Department of Parks, Recreation and Waterfront
Waterfront Capital Improvements Program Division

March 7, 2024

**CITY OF BERKELEY
BERKELEY MARINA DOCKS D & E REPLACEMENT
SPEC. NO. 24-11633-C**

ADDENDUM NO. 2

SITE PLAN — PROJECT LIMITS AND CONTRACTOR LAYDOWN AREA
SCALE: 1" = 50'-0"

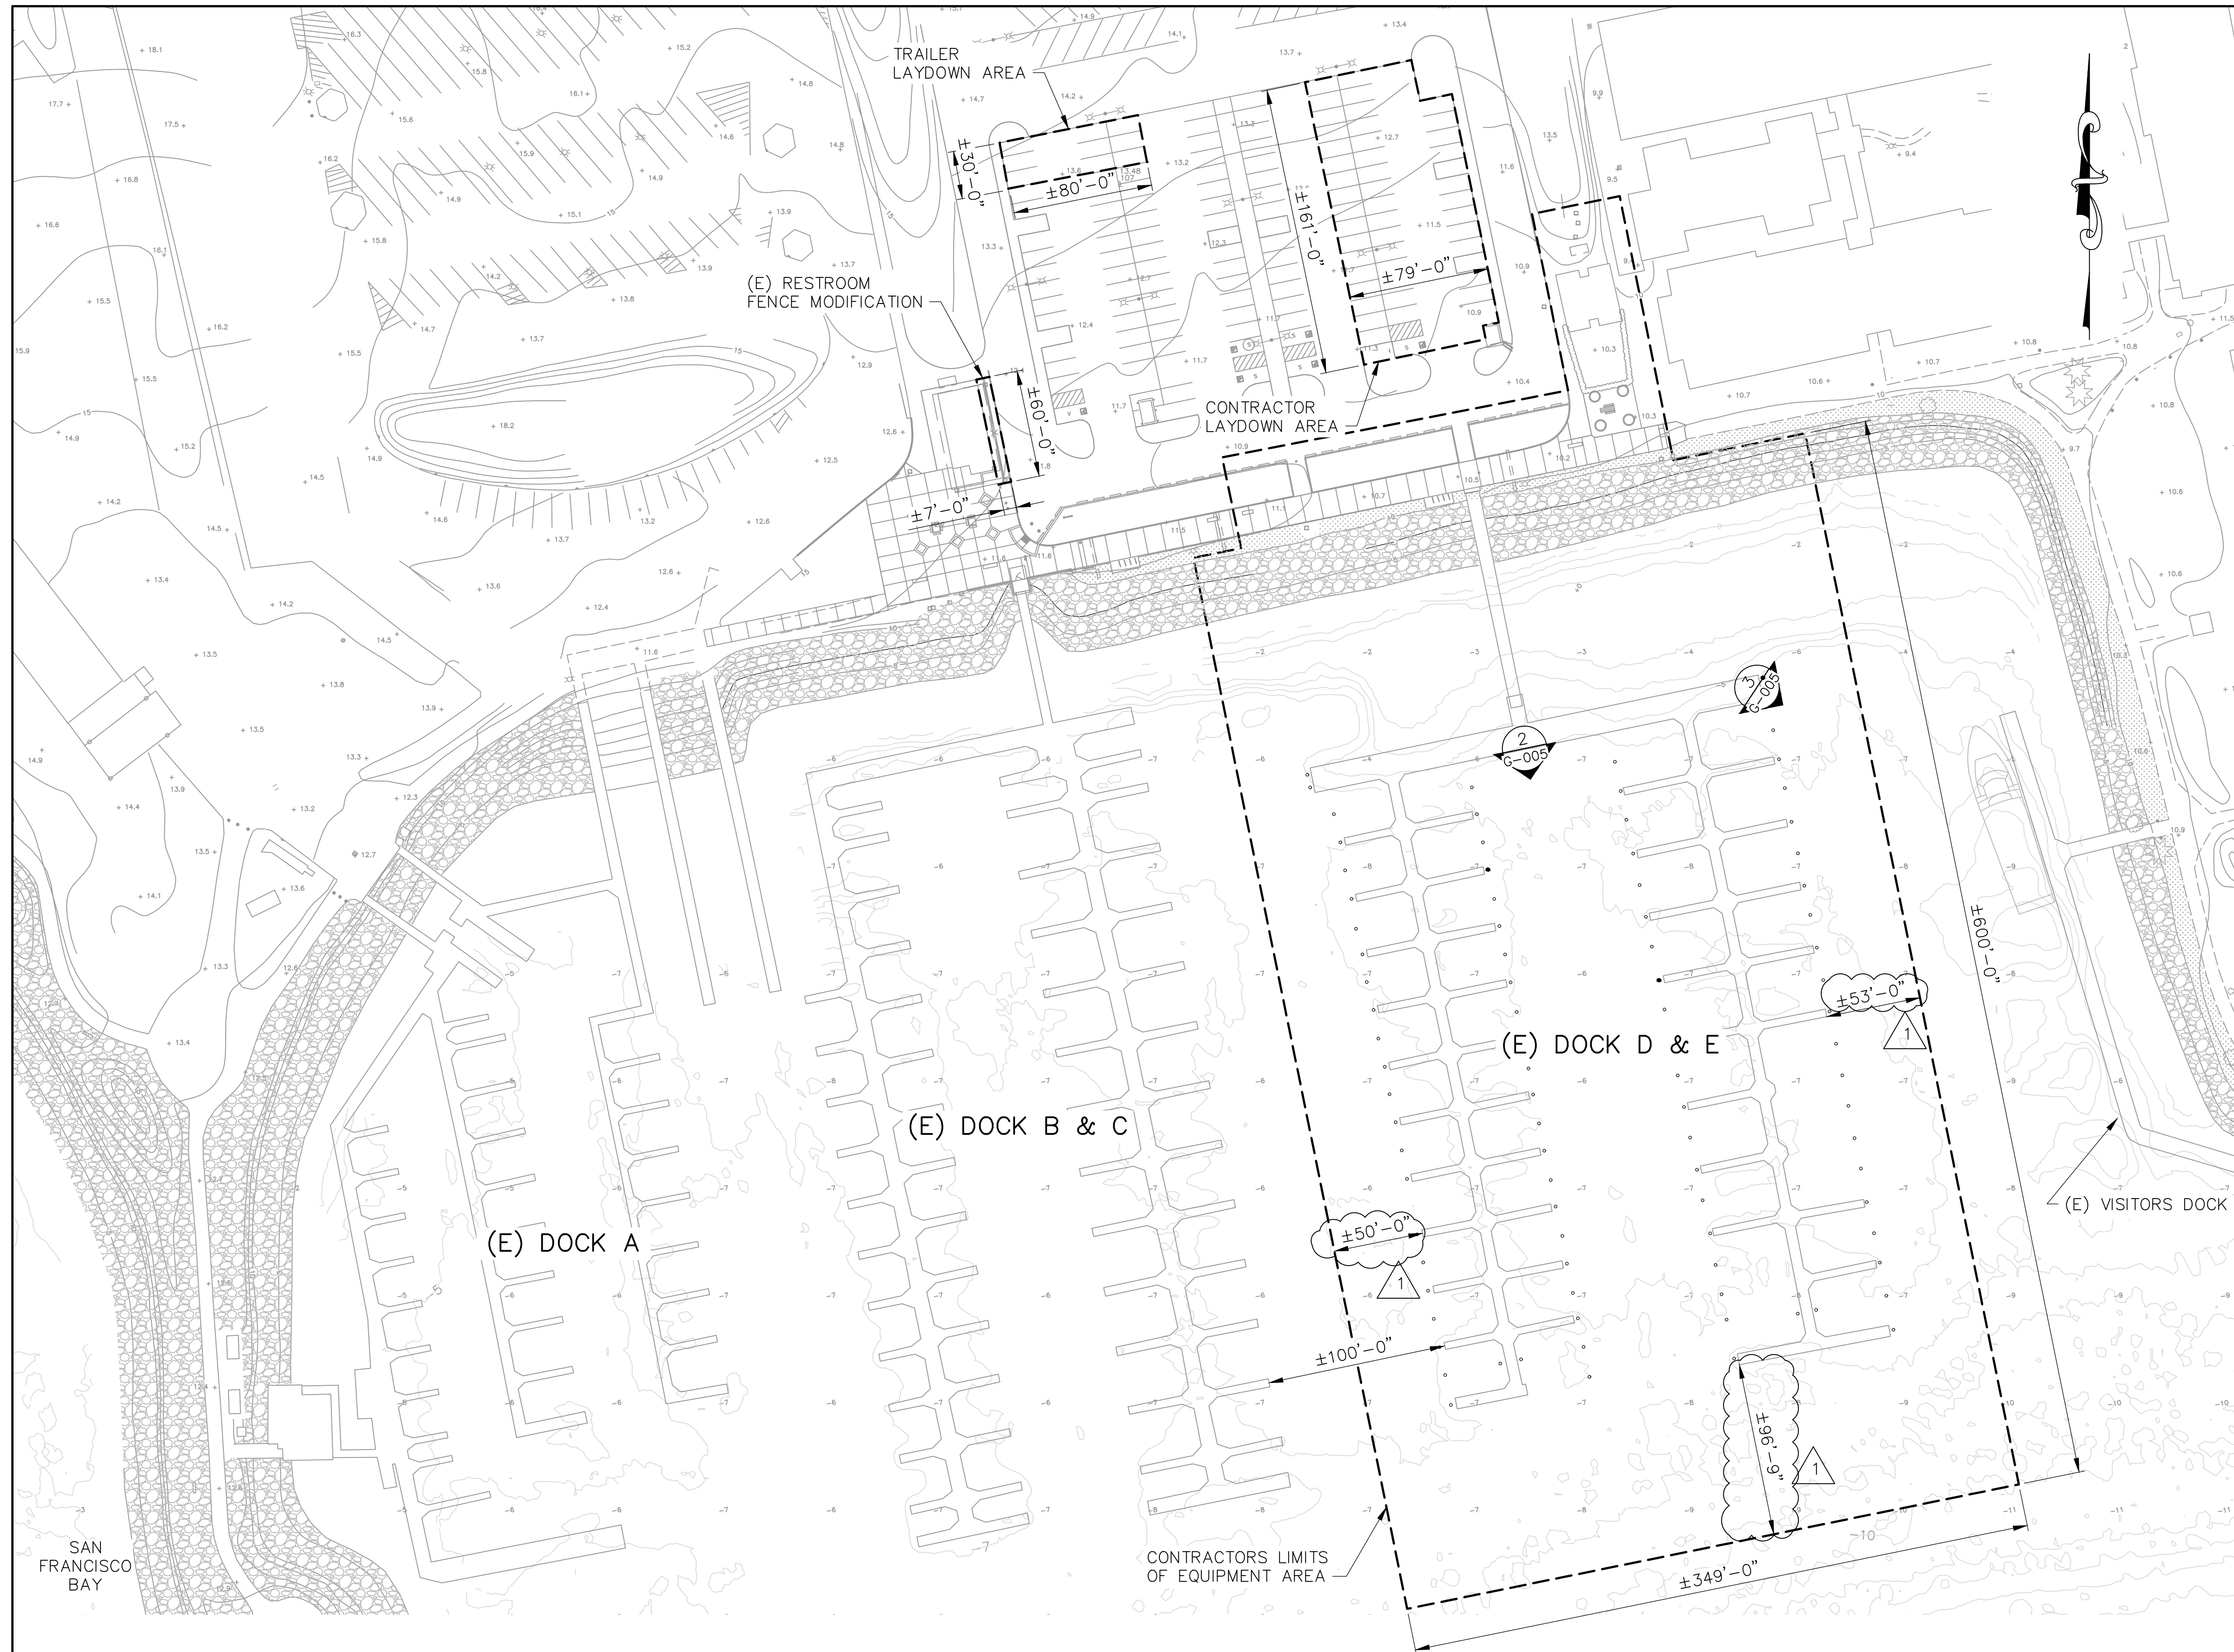
2. **Plans:** Sheet G-005, Project Limits and Contractor Laydown Area
REPLACE with attached revised Sheet G-003
 - Additional information for possible barge mooring within Contractor's Limit of Equipment Area.

3. Can a crane barge and material barge be moored within the marina adjacent to the work area throughout the duration of the project?

Response: Sheet G-005 shows the limits for the contractor's equipment area. This area can be used by the contractor for the duration of the project.

POSSIBLE BARGE MOORING SITE LOCATION BETWEEN DOCK D & E

POSSIBLE BARGE MOORING SITE LOCATION EAST OF DOCK E

DEMOLITION PLAN 
SCALE: 1" = 40'-0"

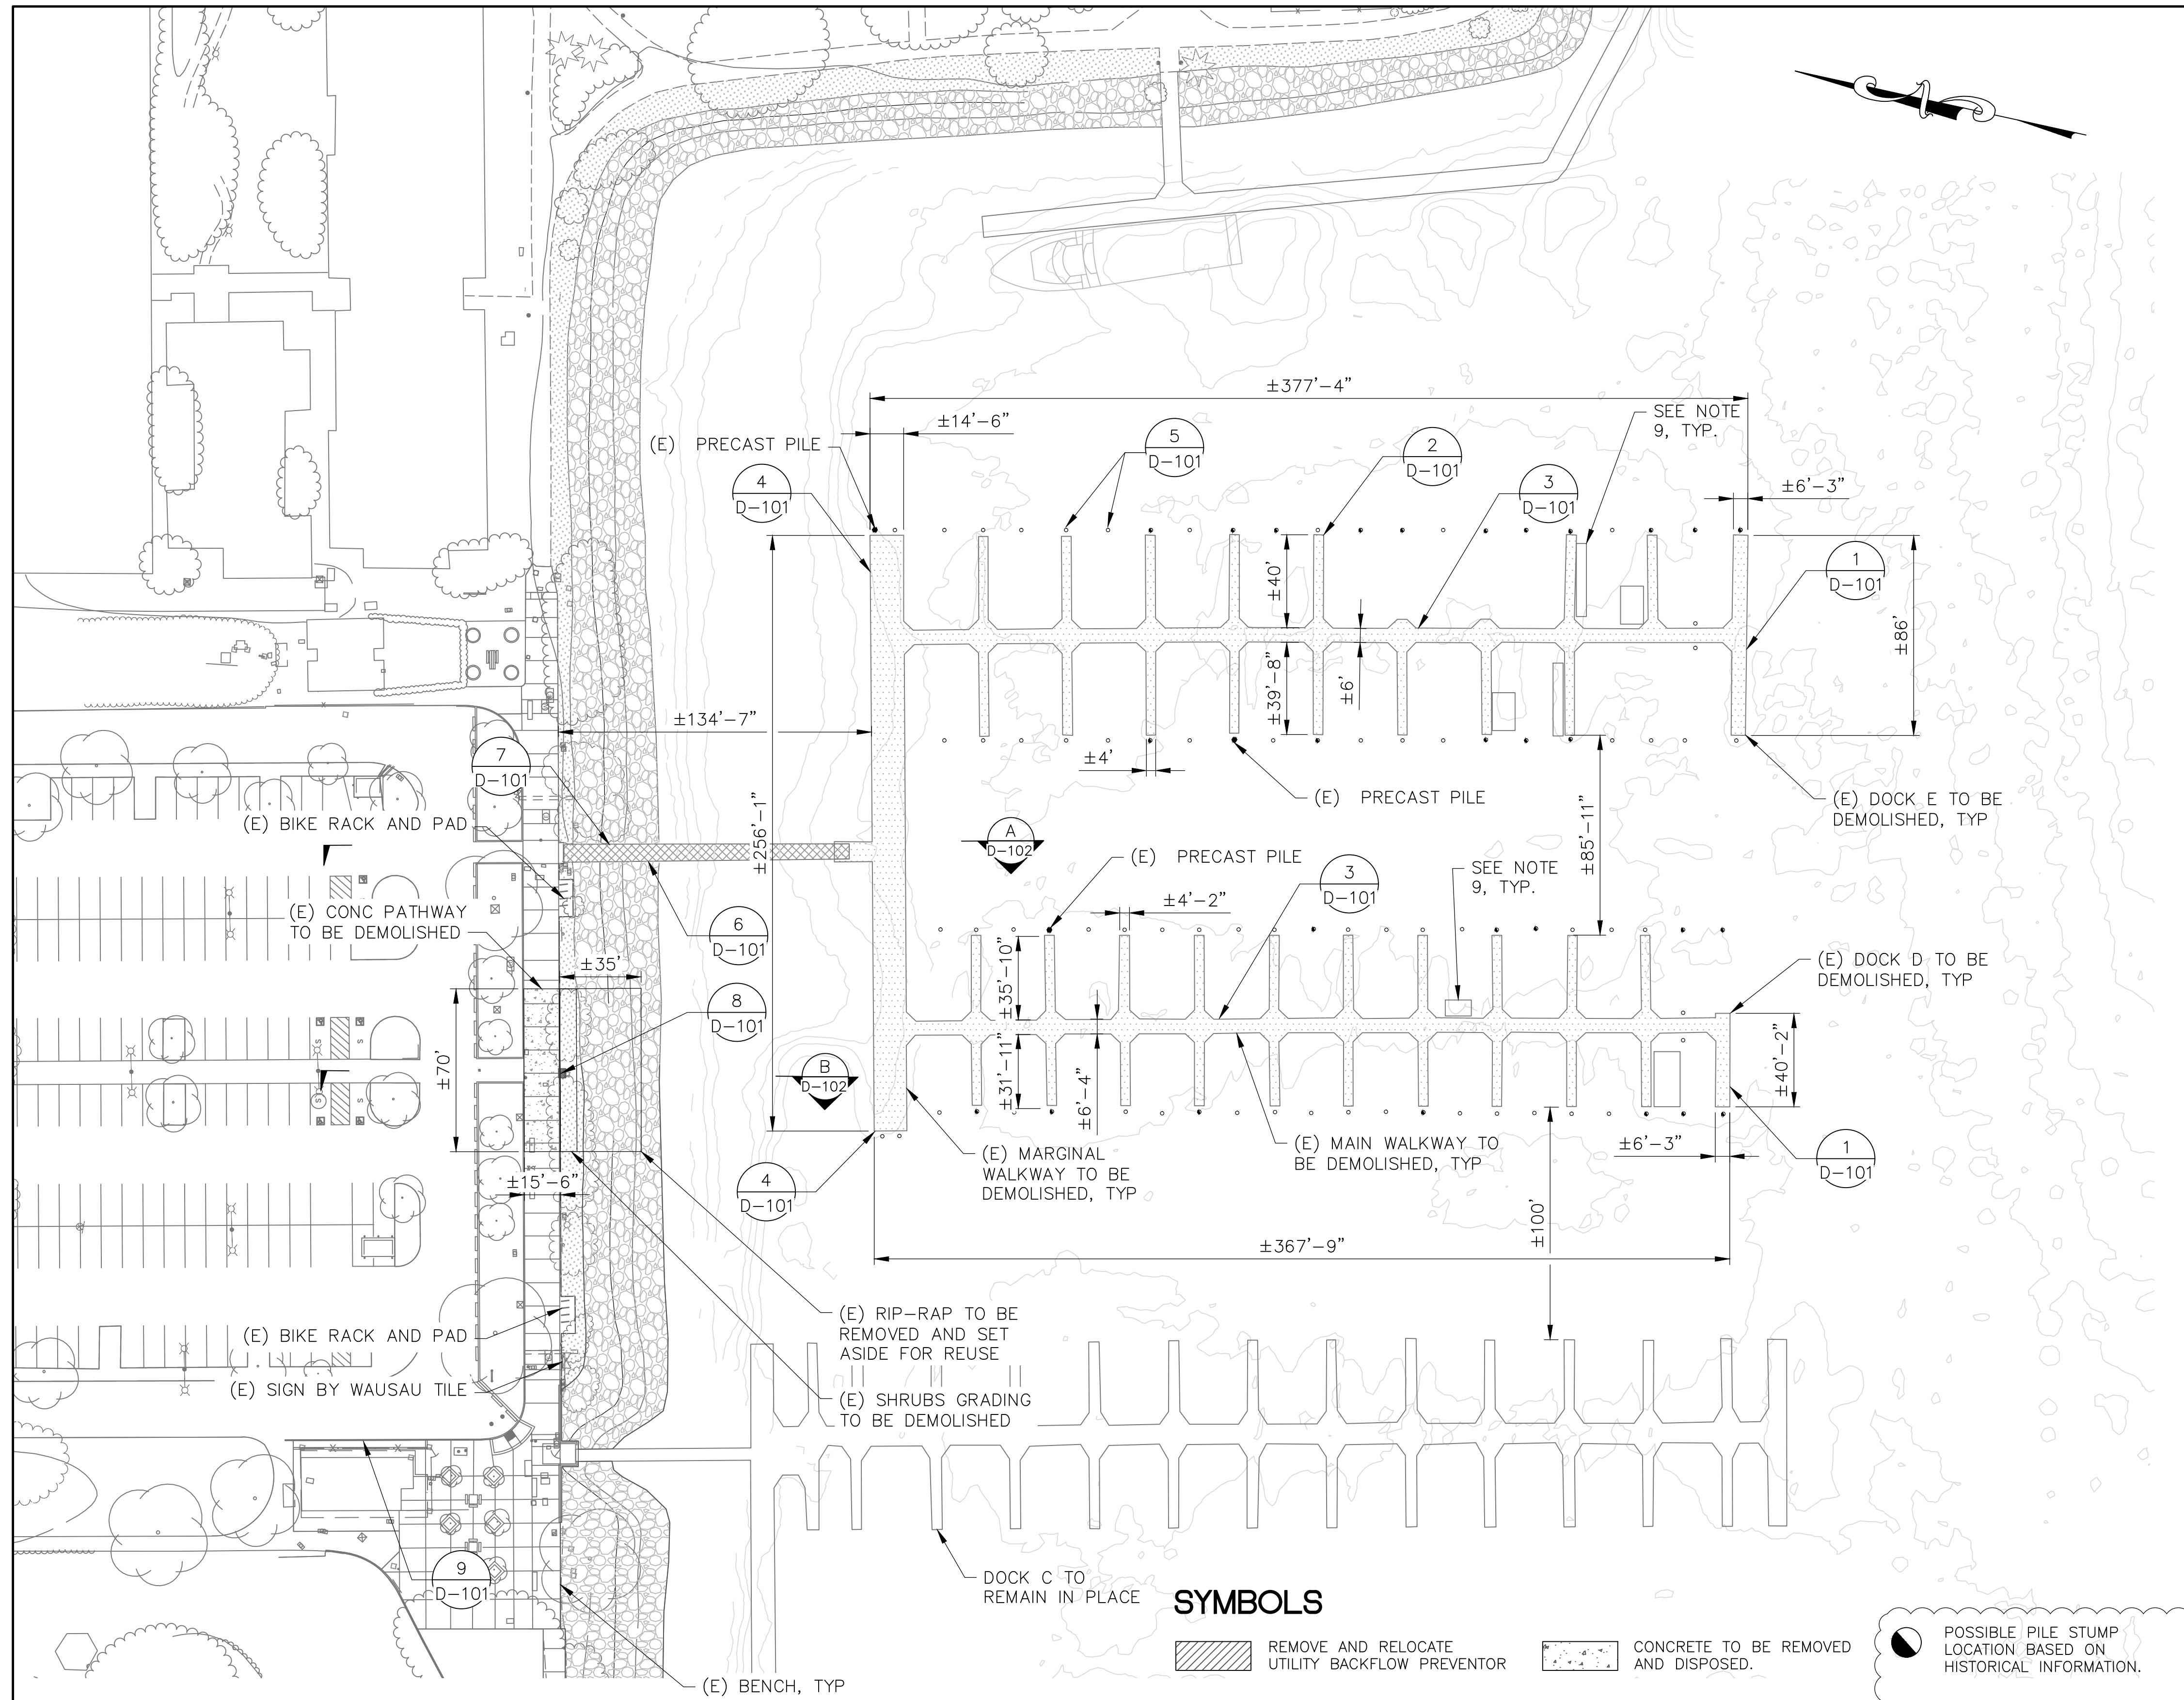
3. **Plans:** Sheet D-100, Demolition, 1 of 2
REPLACE with attached revised Sheet D-100
 - Revisions to show the assumed locations of the missing piles for underwater pile removal.

- Additional information of 3 existing precast concrete piles to be removed.
4. **Plans:** Sheet D-101, Demolition, 2 of 2
REPLACE with attached revised Sheet D-101

5. Per Sheet D-100 Note 2 "Contractor to investigate and report to city locations at double and end tie berths where piles are missing or broken below water. Remove and dispose of pile stubs extending above the mudline." Do these stubs need to be removed entirely or can they be cut at

16. Drawing D-100: Note 2 states to investigate and report missing or broken piles and to remove underwater pile stubs extending above the mudline. Bidders have no way to quantify this work at bid time. Please provide a quantity to assume for bidding purposes for underwater pile removal.

60. On the site walk, we observed at least two concrete piles in the marine demolition footprint that are not identified on the plans. Please clarify if these are intended to be removed as part of the demolition scope and if so, identify location and quantity.

Response: Attached is revised D-100R1 showing the assumed locations of the missing piles. Based on historical information and field assumptions, a total of 26 possible pile stump location has been noted. Encountered pile stumps are to be cut at mudline and disposed.

Response: Attached is revised Sheet D-100 showing the assumed locations of the missing piles. Based on historical information and field assumptions, a total of 26 possible pile stump location has been noted.

Response: Total of 3 precast concrete piles to be removed and disposed of. See attached revised drawings D-100 and D-101 for locations.

SECTION - ABUTMENT WALL (A)
SCALE: 1/2" = 1'-0"

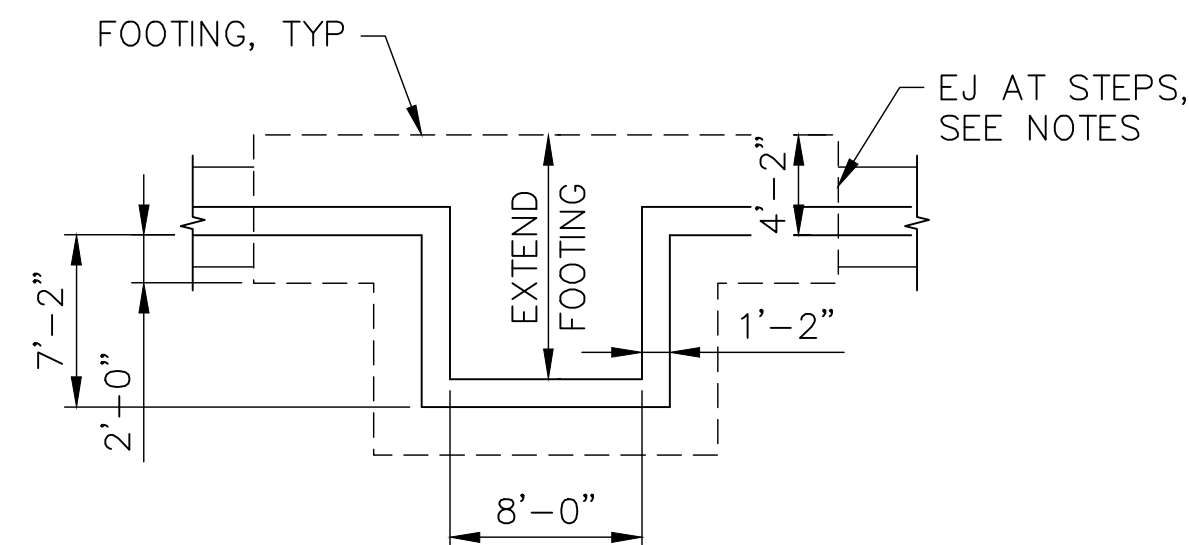
9. Are the expansion joints required in the abutment wall shown on Detail A/C-102 of the drawings?

57. Reference sheet C-102/Section A – notes call out a depth of footing relative to existing grade, but insufficient information is provided to determine wall details. Please provide bottom of footing elevation(s) as well as plan/layout and developed elevation of the wall with steps, changes in design height, etc.

58. Reference sheet C-101/Section A – bottom of excavation/subgrade elevation for the new abutment footing appears to be at approximately elevation 0.0' (MLLW). At this elevation, the excavation will be inundated with water at all times. Plans and specs (31 23 00.20) require 90% and 95% relative compaction of subgrade and aggregate base course, respectively. Specification section 31 23 19 requires excavations be free of water until backfilled to final grade. Significant effort and expense will be required to achieve these specs and details (e.g. temporary cofferdam). Please confirm if this is the intent or clarify/modify the details and requirements for the abutment.

Response: Yes, expansion joint between abutment and concrete sidewalk are required.

Response: See revised drawing C-102. It is recommended for fill underneath footing to be compacted at low tide. Possibility of replacing rock with a minimum of 4" (-) size with crushed rock carefully placed in order to limit compaction requirements. Replacing bedding material to
